Errata Sheet

Rel. 1.4, 2016-11

Device	**XMC1300**
Marking/Step	**EES-AB, ES-AB, AB**
Package	**PG-TSSOP-16/28/38, PG-VQFN-24/40**

Figure 1 Clock Selection Diagram for CCU4/CCU8

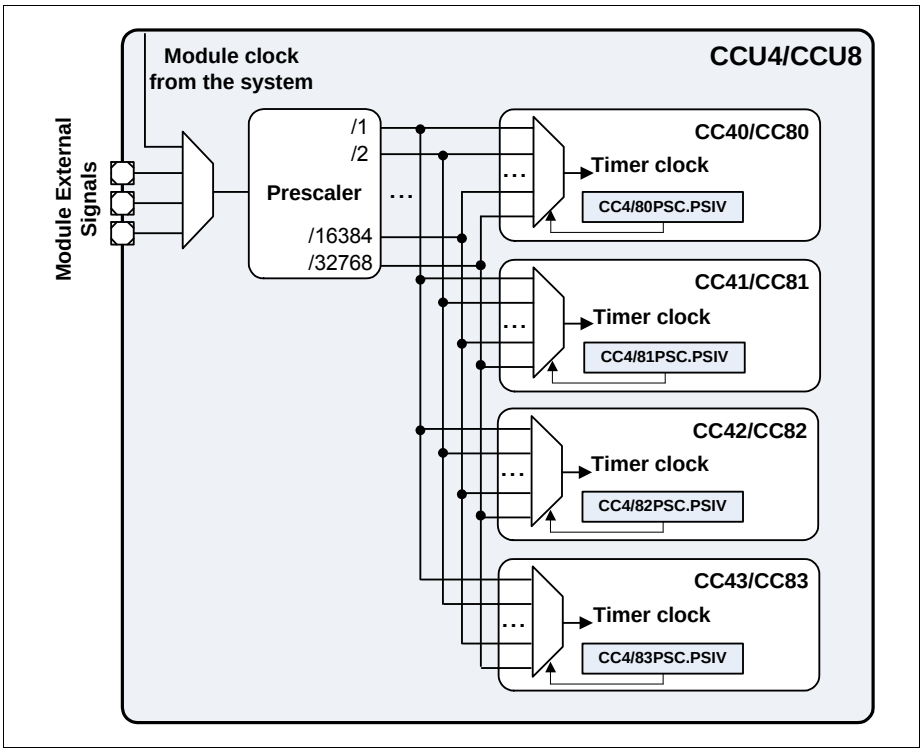
Currently is only possible to use an external signal as Timer Clock when a division ratio of 2 or higher is selected. When no division is selected (divided by 1), the external signal cannot be used.

The user must program the PSIV field of each Timer Slice with a value different from 0000_B - minimum division value is /2.

None.

Figure 2 Parity Checker diagram

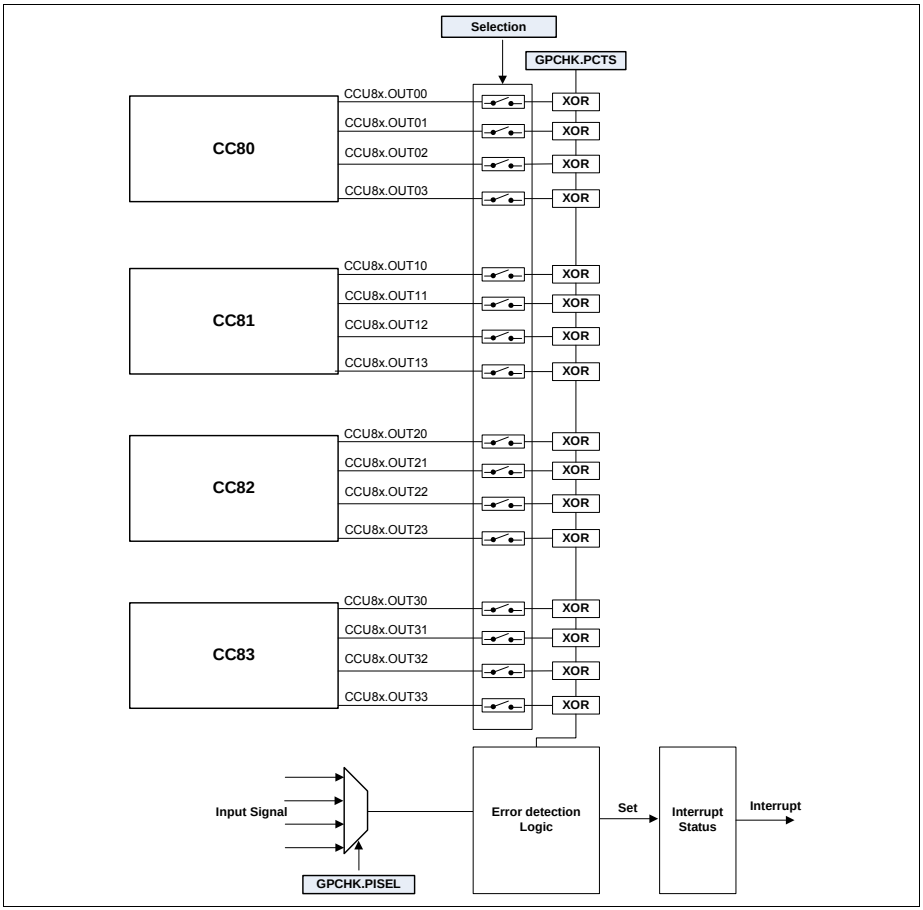
Each CCU8 module also contains a function called Parity Checker. This Parity Checker function, crosschecks the output of a XOR structure versus an input signal, as seen in Figure 1.

When using the parity checker function, the associated status bitfield, is cleared automatically by hardware in the next PWM cycle whenever an error is not present.

This means that if in the previous PWM cycle an error was detected and one interrupt was triggered, the software needs to read back the status register before the end of the immediately next PWM cycle.

Not ORing the Parity Checker error interrupt with any other interrupt source. With this approach, the software does not need to read back the status information to understand what was the origin of the interrupt - because there is only one source.

Figure 3 CCU8x concatenation feature resource configuration - a) without external count function; b) with external count function

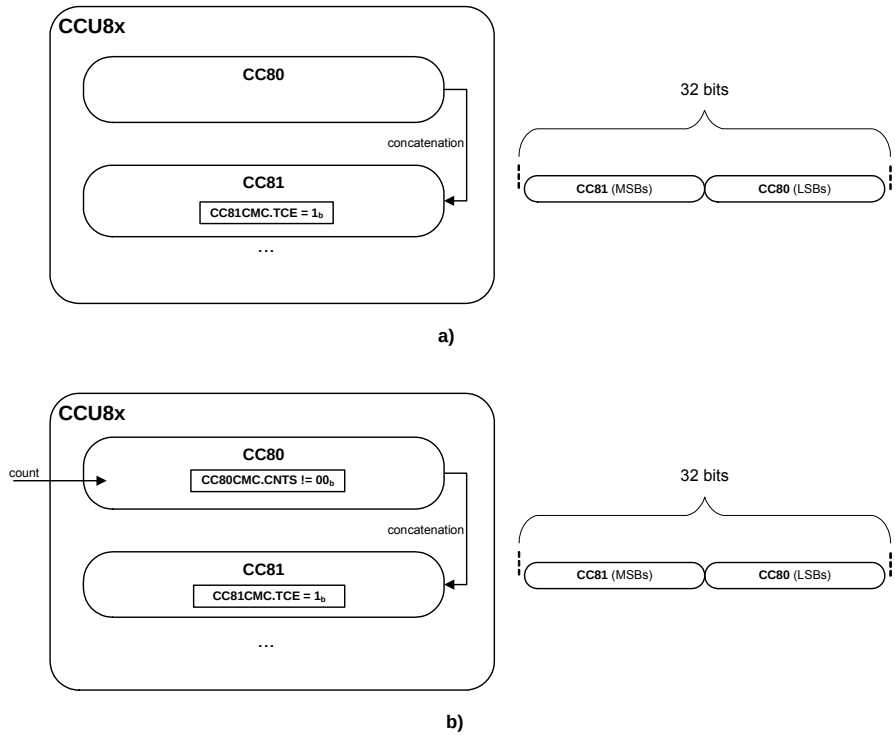
It is also possible to use an external signal as a count trigger. This means that when using an external count signal, the LSB timer is incremented each time that a transition on this external signal occurs - Figure 1 b).

When an external count signal is enabled - by programming the CC8yCMC.CNTS with 01_B, 10_B or 11_B - the concatenation function does not work. One cannot use in parallel the timer concatenation and external count signal features.

Note: On Figure 1, the count signal is used in CCU80 because this timer represents the LSBs. While the count signal could be enabled in the MSB timer (CC81), this does not make sense when the timers are concatenate - because the count should be used to increment the LSB timer. The LSB timer will then in each wrap around, increment the MSB timer.

None

Figure 5 Different index signal types

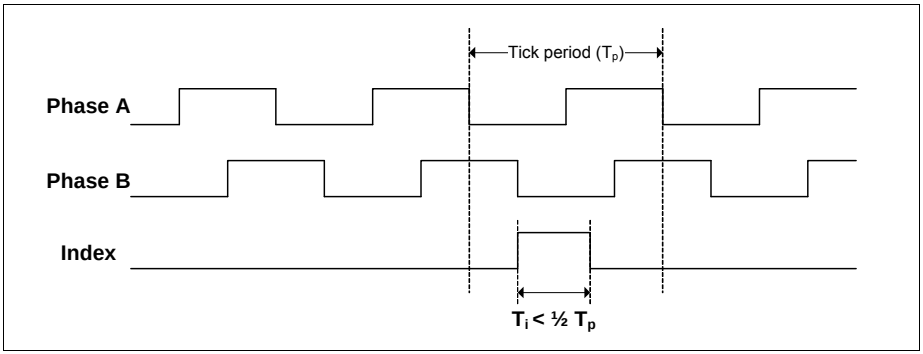
When the index signal is smaller than 1/2 of the tick period, the POSIF module is not able to decode this signal properly, Figure 2 - notice that the reference edge of the index generation in this figure is the falling of Phase B, nevertheless this is an example and depending on the encoder type, this edge may be one of the other three.

Due to this fact it is not possible to use the POSIF to decode these type of signals (index with duration below 1/2 of the tick period).
